SUMMARY OF CONCERNS IN RELATION TO THE PROPOSED NORTHCONNEX TUNNEL

This is an objection to many aspects of the proposed NorthConnex tunnel.

SECTION A: THE CONNECTIVITY OF NORTHCONNEX SOUTHERN VENTILATION FACILITY AT THE SOUTHERN INTERCHANGE, THE SOUTHBOUND TUNNEL IN PARTICULAR

MOTORWAY OPERATIONS COMPLEX - SOUTHERN VENTILATION FACILITY - SECTIONS
M1-M2-5000-DR-JD-0525

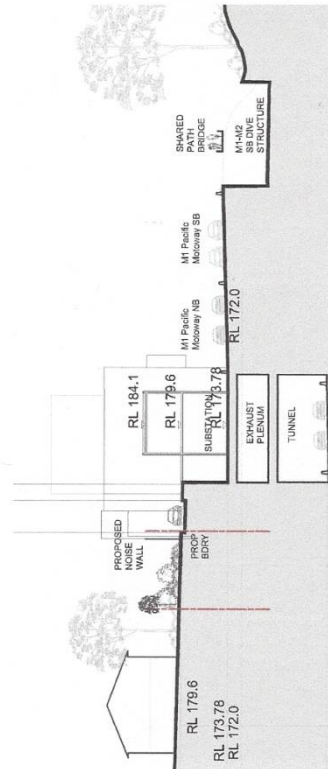
5. *EIS Volume 4, Technical working papers - Urban Design, 6.0 Operational Ancillary Facilities*
EIS Page 99 there is the diagram "Motorway Operations Complex – Southern Ventilation Facility – sections. *Page 10 below* The diagram has the cryptic label "Connection to tunnel TBC". What does TBC stand for? To be considered? Why is tunnel singular? Which tunnel is the diagram referring to northbound or southbound? There is no diagram showing any connection from the Southern Interchange ventilation facility to either the northbound or the southbound tunnel in any way
AND YET

- Diagrams need to be provided showing the inter-relation between the shaft, the ventilation outlet and the motorway operations centre with a clear description of what is to be constructed and how it will operate.
- The community needs irrefutable evidence that the polluted air from the southbound tunnel exit portals will not be allowed to flow like an invisible sewer through West Pennant Hills, North Rocks, Carlingford and Beecroft.

M1-M2-5000-DR-UD-0556
NORTHERN VENTILATION FACILITY - LONG SECTION

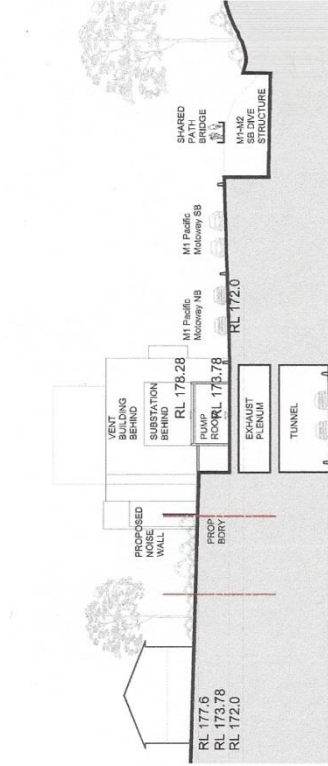
EIS page 135 *Page 11 below* there is a very explicit diagram showing the *Northern Ventilation Facility – cross section*.

EIS page 134 *Page 12 below* there is a very explicit diagram showing the *Northern Ventilation Facility – long section*.

Why are there no comparable diagrams for the Southern Interchange and the Southern Ventilation facility?

MOTORWAY OPERATIONS COMPLEX - SOUTHERN VENTILATION FACILITY - SITE SECTION 1-1
M1-M2-5000-DR-UD-0713

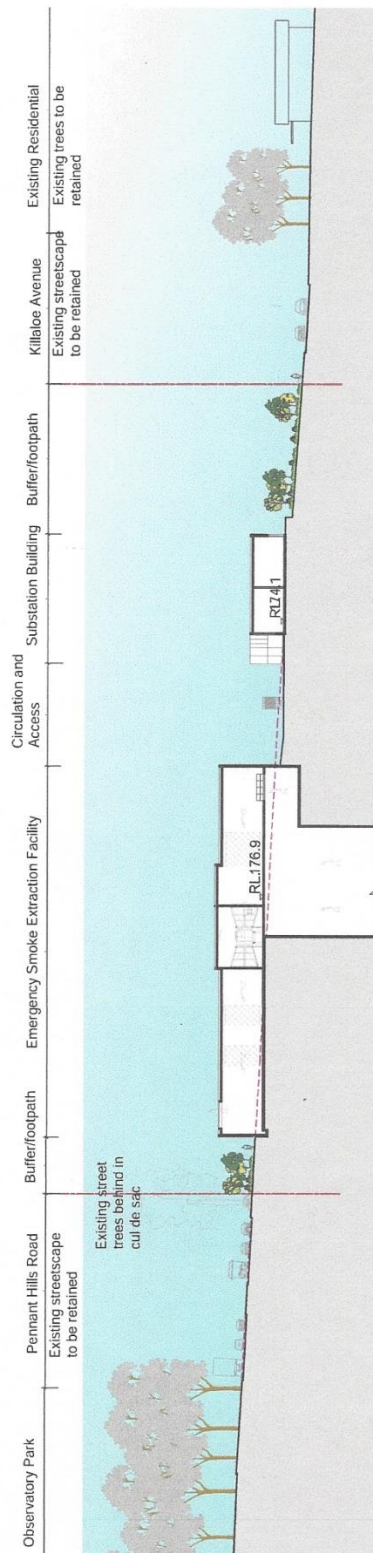
6. *EIS Volume 4, Technical working papers Urban Design, 8.0 Landscape Design*
EIS Page 176 is the diagram "Motorway Operations Complex – Southern Ventilation Facility – Site 1-1". *Page 13 below* The diagram does not show any connection to either the northbound or southbound tunnel. In the same Landscape Design section, EIS Page 182 is the diagram "Wilson Road Tunnel Support Facility –Section" *Page 14 below* which clearly shows the connection to the tunnels. In the same Landscape Design section, EIS Page 189 is the diagram "Northern Ventilation Facility – Landscape Concept Section". *Page 15 below* This also clearly shows the connection to the tunnels.
